Work Package 2 Report “Valuing the Capacity of Intermittent Generation in the SWIS” - REGWG Comments			
Issue	Comments	MMA Response	Member feedback
Western Power			
LOLP criteria	<p>Analysis seems to be based on the assumption that shedding 473 MW of load for an hour is acceptable as this equates to the 0.002% energy at risk. However the current capacity requirements are based on 8.2% of the forecast peak which is providing a lower energy at risk than 0.002%.</p> <p>It should be made clearer in the report that according to the energy at risk criteria we are accepting that lack of wind generation will result in load shedding during peak periods.</p> <p>The energy at risk of 473 MW is based on a 10% POE system forecast. The 50% POE forecast is only approximately 160 MW less than the 10% POE forecast. This means that on average we are prepared to accept the loss of 313 MW of load during the peak period.</p> <p>More discussion is required on whether assigning capacity credits based on a 0.002% energy at risk criteria is valid.</p>	<p>The assumption about 473 MW load interruption in one hour is incorrect. No claim has been made about the maximum amount of load shedding in one hour and n

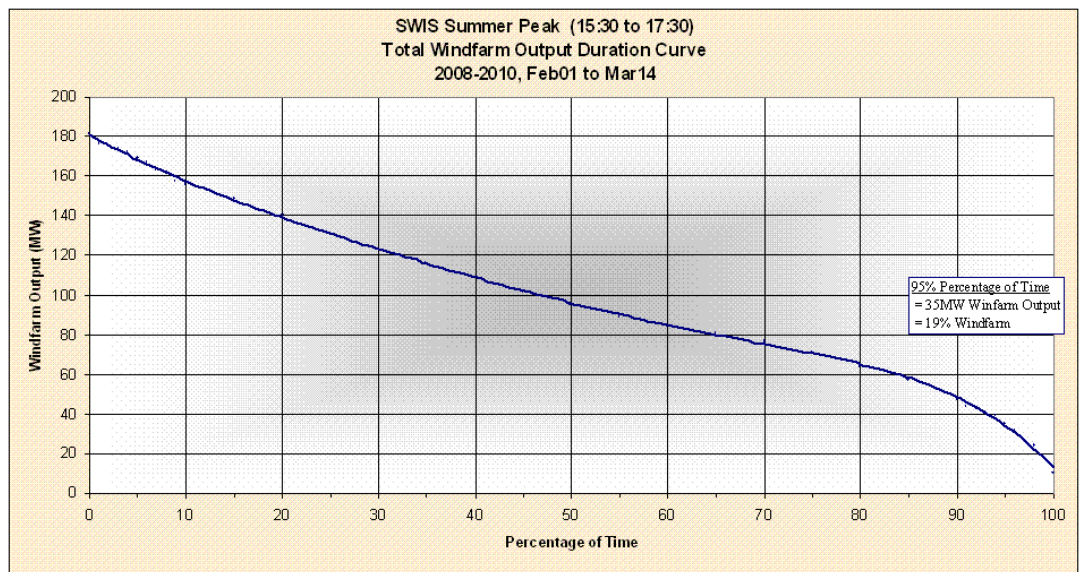
<p>LOLP</p>	<p>The unserved energy (USE) approach may be used to determine capacity requirement to manage risks to power system security. Risk is a combination of impact and probability. Risk also has quantifiable parts and intangible parts.</p> <p>In considering the quantifiable risk impact on SWIS power system security System Management believes that the 0.002% USE approach is more appropriate where the load factor is high and the load duration</p>	<p>Certainly the maximum amount of power at risk is greater in a peakier system for a given USE standard. Analysis of the optimal reliability standard for Victoria showed that the economic level was 0.004% due to the cost of reserve, the very little energy at risk over the sharp peak and the way load shedding was distributed. It would be feasible to sample event characteristics and put a probability on load shedding events by magnitude to address these issues.</p>	<p>As indicated above, a multiple contingency now becomes, for the first time:</p> <ul style="list-style-type: none"> • 8.2% of generation unavailable, and • wind output not reaching the capacity allocation.

*SWIS Summer (Feb01-Mar14) Windfarm Generation
Percentage Of Time Duration Values*

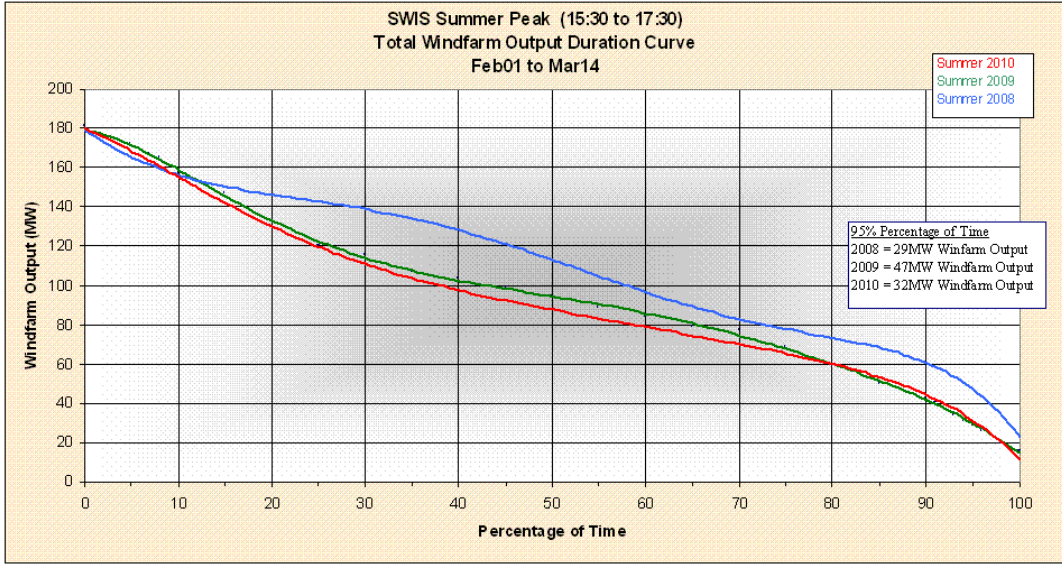
Other jurisdictions	<p>Another analysis performed by System Management, using similar methodologies to those adopted by Ireland and AEMO?? to examine the output of windfarms over the summer peak intervals, has identified the average MW production of wind over the peak intervals during the summer months (1 February to 14 March) for the years 2008 to 2010. It is evident that the 95% POE output of the existing windfarm fleet in SWIS is higher during the summer peak interval periods than for the whole of the year with a trend for higher output closer to the peak. This accords with MMA’s findings. However it is also evident however that the 95% confidence average output over the summer peak intervals ranges between 9.5% and 26.1% of connected capacity in the years studied much less than the average using the top 250 to 750 intervals. This reflects System Managements concern that the values proposed by MMA may be overly optimistic. The following table and graphs illustrate the findings.</p>	<p>It is not reasonable that the 95% POE output should be the sole basis for capacity credits due to the value of production above that level in reducing load at risk.</p>	<p>Due to variation in wind output that clearly exists, it can only be shown that on average, wind farm outputs will be above the 95% reliability level. With an increase in the quantity of windfarms, system security is more likely to be impeded. If system security is impeded then the value of any production is questionable.</p>
